SAND2005-7339

Review of the Independent Risk Assessment of the Proposed Cabrillo Liquefied Natural Gas Deepwater Port Project

**REVIEW OF THE INDEPENDENT RISK ASSESSMENT OF THE
PROPOSED CABRILLO LIQUEFIED NATURAL GAS
DEEPWATER PORT PROJECT**

Figure 4: Sandia calculation of pool fire hazards.

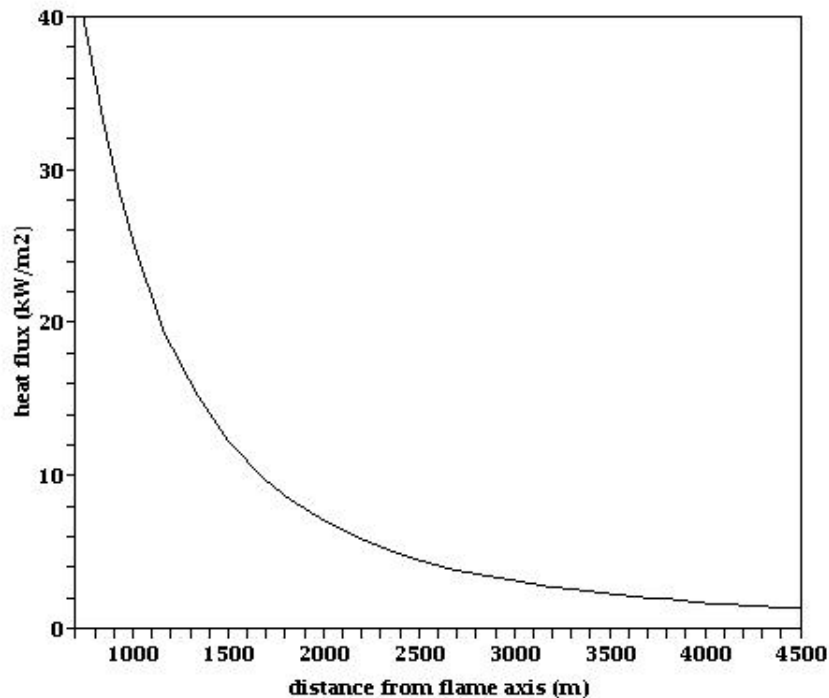
Sandia reviewed and assessed the ACE pool fire calculations by calculating heat flux as a function of distance as shown in Figure 4. The Moorhouse correlation was used for flame height and a surface emissive power of 220 kW/m², as well as a burn rate of 3 x 10⁻⁴ m/s, and a transmissivity of 0.8 were used. The Moorhouse correlation and view factors can be found in the SFPE Handbook of Fire Protection Engineering, 2nd edition¹³. Sandia pointed out that the 3rd edition has this equation misprinted where the leading factor should be 6.2 instead of 62. Both the Sandia and ACE results included this correction. The Sandia results are in close agreement with the results by ACE. The model used is appropriate given the absence of obstacles. The assumptions made are reasonable given the current knowledge of the required input parameters and should provide a conservative estimate of thermal hazard distances.

Figure 5: Sandia calculation of flash fire at 60 minutes after dispersion.

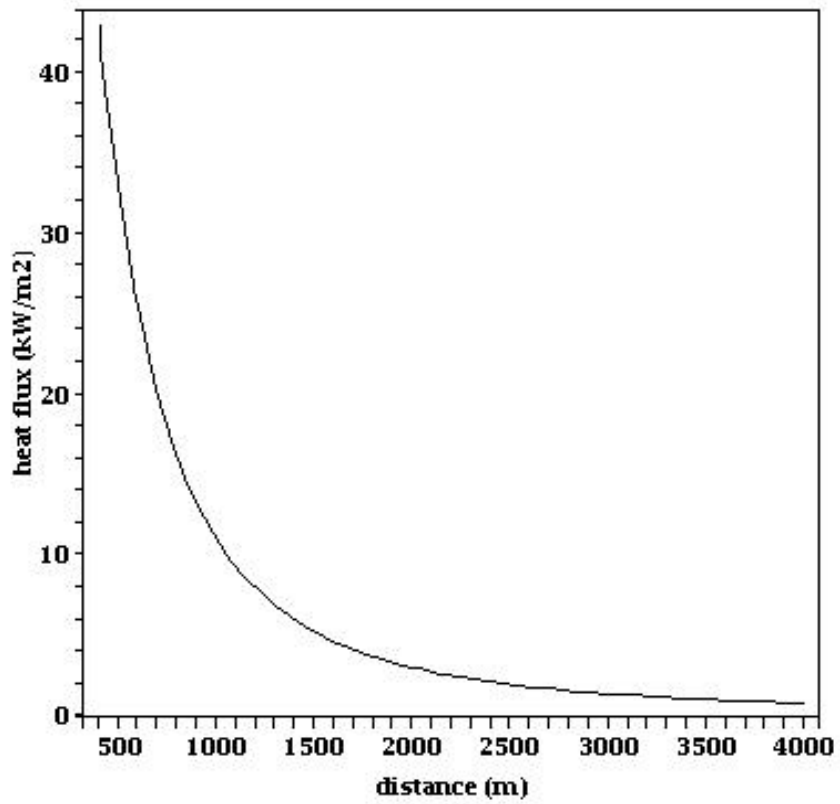
Sandia reviewed and assessed the flash fire results by calculating heat flux as a function of distance shown in Figure 5. The same input parameters were used as ACE except a surface emissive power of 220 kW/m² and an upward velocity of 0.2 m/s were used. This upward velocity will give a flame height to cloud height ratio of 10 which is what was found from the Coyote experiments on vapor cloud fires¹⁵. This approach results in a maximum flame width of 750 m. The results are in close agreement with the results by ACE. The model used and the assumptions made should provide a conservative estimate of the thermal hazard distances. The results are also conservative because of the transient nature and spatial variability of vapor cloud fires. Heat flux levels will not be maintained for durations required to cause injury at certain locations relative to the cloud. Thus, a global hazard zone as provided by ACE should be conservative.
